**PSEG** Public Service  
Electric and Gas  
Company

HOPE CREEK GENERATING STATION  
DOCKET NO. 50-354  
DRAFT SAFETY EVALUATION REPORT  
FSAR QUESTION 421.10

ATTACHMENT

QUESTION 421.10 (SECTION 7.1 & 7.2)

FIGURE 7.6-11

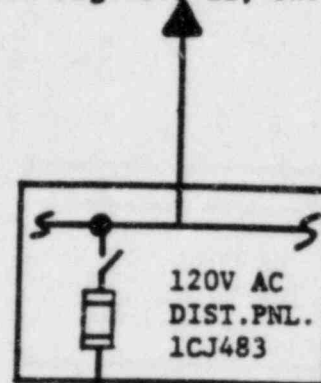
Electrical protection assemblies (EPAs) identical to those used in the reactor protection system (RPS) (described in Section 8.3.1.5.4) are installed between the power range NMS and the two 120V AC feeders from the UPS power sources (see Figure 7.6-11). The EPAs ensure that the power range NMS never operates under degraded bus voltage or frequency conditions (undervoltage, overvoltage, underfrequency). The power range NMS panel (10C608) was analyzed with this power supply configuration to ensure that no single failure of the power range NMS could inhibit the proper operation of the reactor protection, ~~system or any other safety system~~, required for the safe operation of the plant. The interfaces between the power range NMS and the RPS have adequate provisions for separation. The RPS cabling external to the NMS panel conforms to the separation guidelines of Regulatory Guide 1.75, which the RPS must satisfy. Within the panel, where the cable and wiring runs to the different RPS divisions do not conform to the Regulatory Guide 1.75 separation criteria, fire-resistant "Sil-Temp" tape is wrapped around the cables and wires. This eliminates the possibility of fault propagation between the RPS divisions. In accordance with paragraph 5.6.2 of IEEE Standard 384, this tape has been demonstrated to be acceptable. Separation criteria for the rod block monitor, recirculation flow control, reactor manual control, and the redundant reactivity control systems has not been changed.
